Public Consultation Procedure under Part 8 of the Local Government (Planning and Development) Regulations 2001 – 2013

1. Old Bawn Park, Dodder Valley
2. Corkagh Park (Outer Ring Road)
3. Griffeen Valley Park (Lucan Leisure Centre)

Recommendation:**Site 1 – Dodder Valley Park @ Old Bawn Road:**

Extract from Part 8 Display – Proposed Site Layout

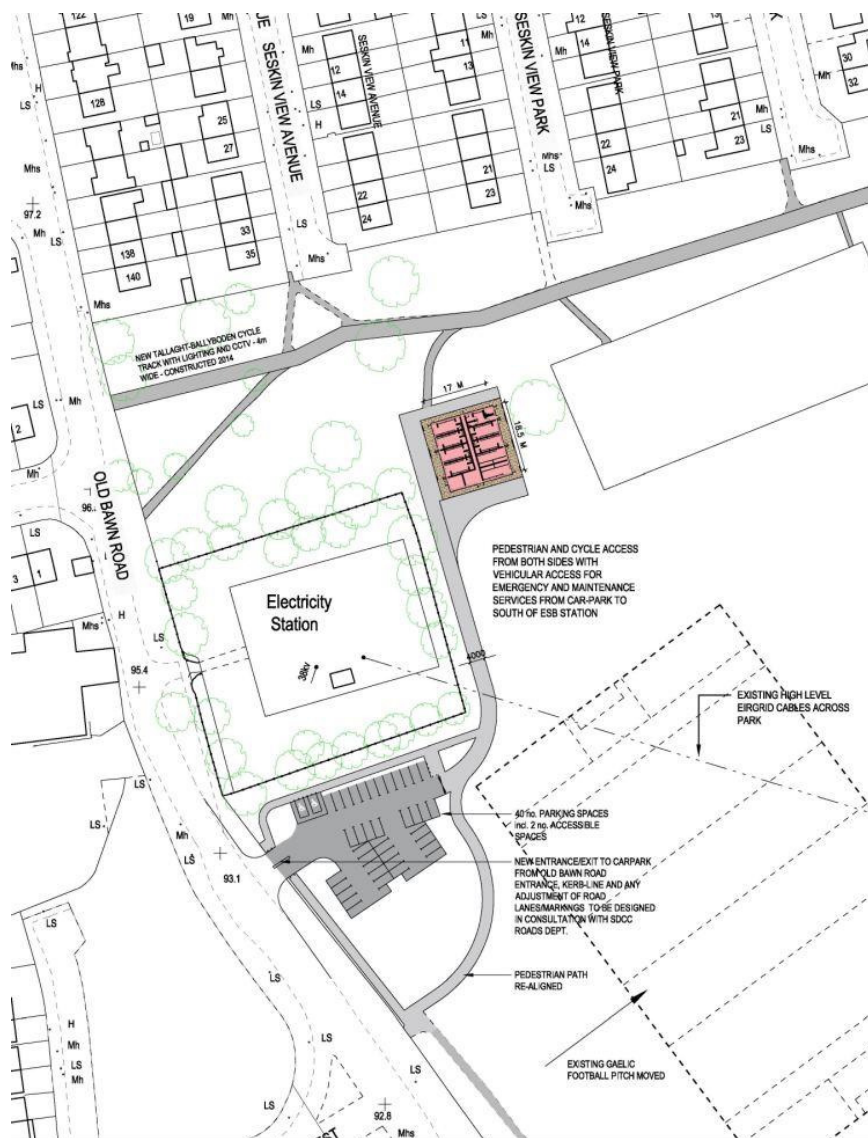
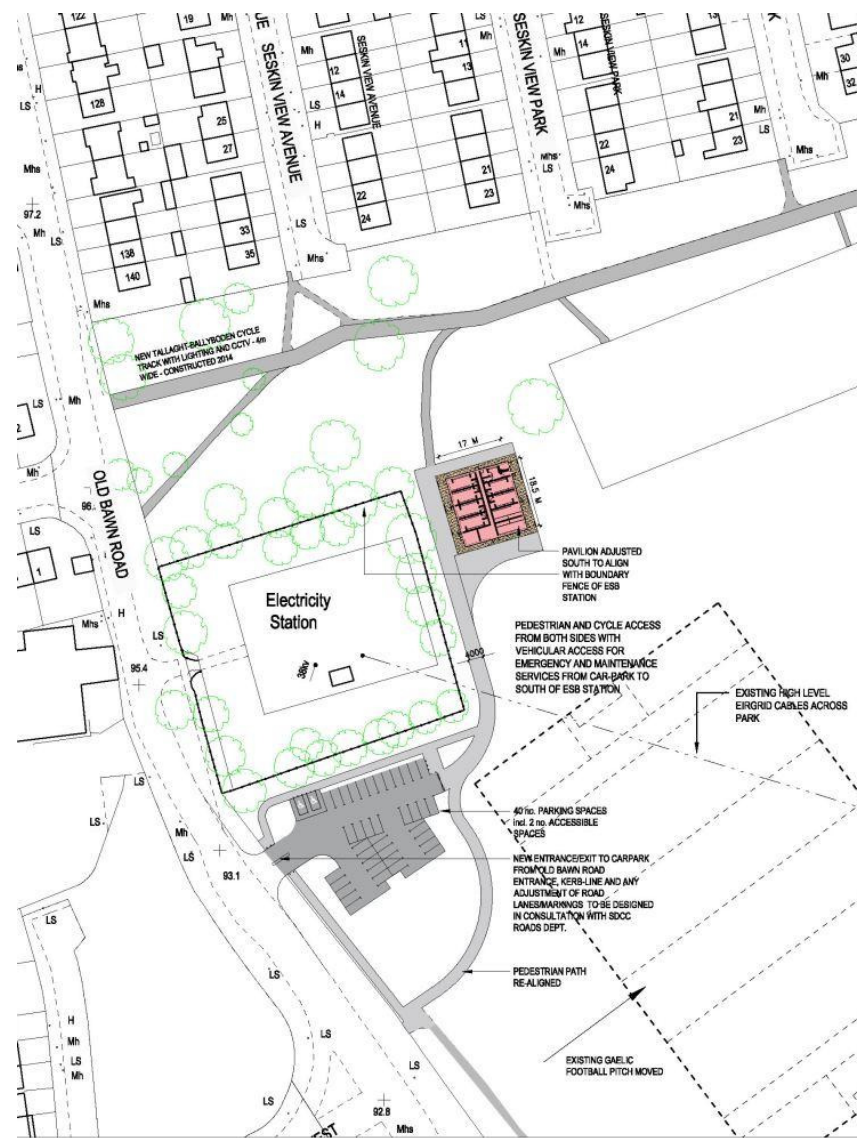
The main objections to the proposal concerns two issues:

- Location of the pavilion
- Design of the pavilion

In relation to the location it has been decided to move the pavilion further away from the Seskin View Housing Estate and in line with the north boundary of the ESB sub-station. This will reduce the impact on the houses in Seskin View and it will now be approximately 65m from the proposed site – the original proposal was approximately 40m from the houses. This relocation is considered to be a suitable distance to reduce the impact on the residential amenity.

Adjusted Proposed Site Layout – Pavilion moved Southwards on the site
